ACCESSION NBR: 8204190066 DOC. DATE: 82/04/06 NOTARIZED: NO DOCKET #
 FACIL: 50-244 Robert Emmet Ginna Nuclear Plant, Unit 1, Rochester G 05000244
 AUTH. NAME AUTHOR AFFILIATION
 MAIER, J. E. Rochester Gas & Electric Corp.
 RECIP. NAME RECIPIENT AFFILIATION
 CRUTCHFIELD, D. Operating Reactors Branch 5

SUBJECT: Forwards clarification of util responses re NUREG-0737, Items
 I.A.2.1, "Upgrading Reactor Operator & Senior Reactor
 Operator Training Qualifications" & Item II.B.4, "Training
 to Mitigate Core Damage."

RE: Mr. Crutchfield letter of March 23, 1982 concerning
TMI Action Plan Items I.A.2.1 and II.B.4.

Figure 6.2-2

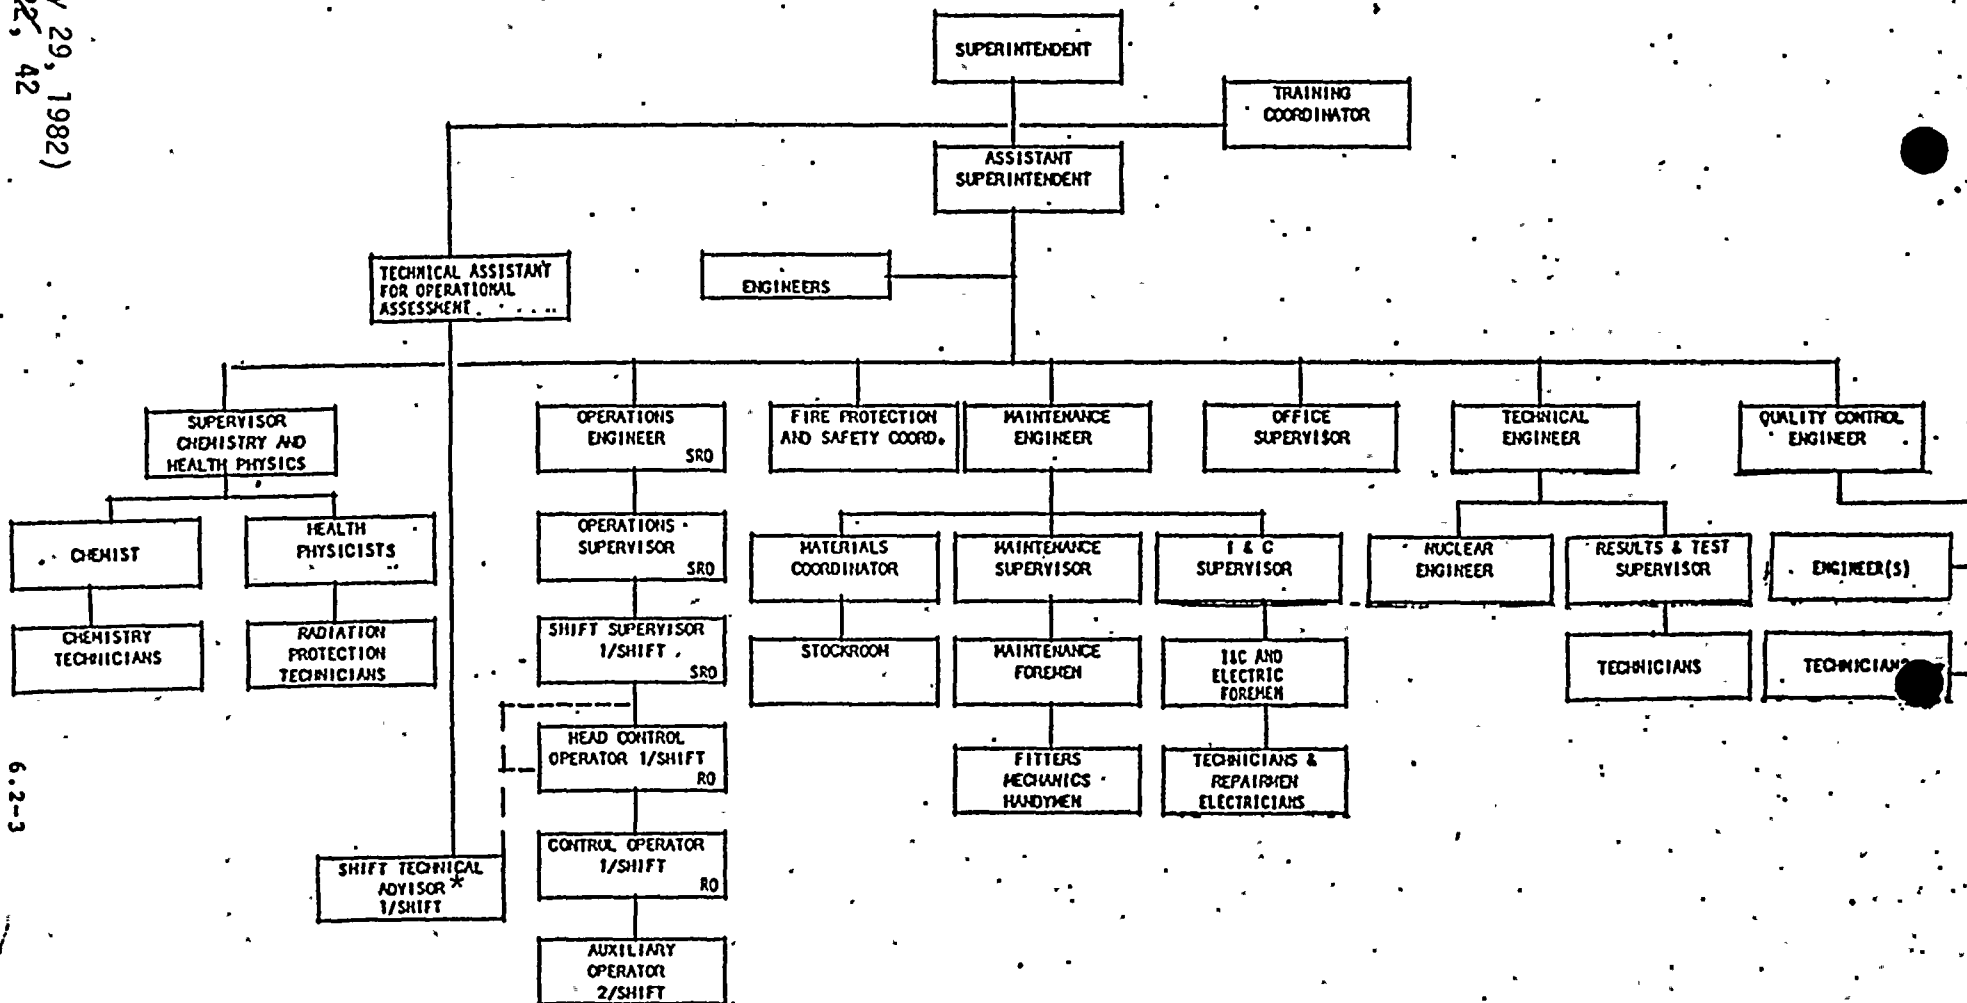
2. Are the lectures and quizzes on the subject of accident mitigation given to shift technical advisors and operating personnel from the plant manager through the operations chain to the licensed operators? If they are, would you please provide the titles of the people who are trained and an organization chart which illustrates their position in the operations chain?

Yes, all of mentioned personnel participated in Mitigating Core Damage during the Summer of 1981.

Superintendent
Assistant Superintendent
Operations Engineer
Operations Supervisor
Shift Supervisor
Head Control Operator
Control Operator
Technical Assistant for Operational Assessment
Shift Technical Advisor
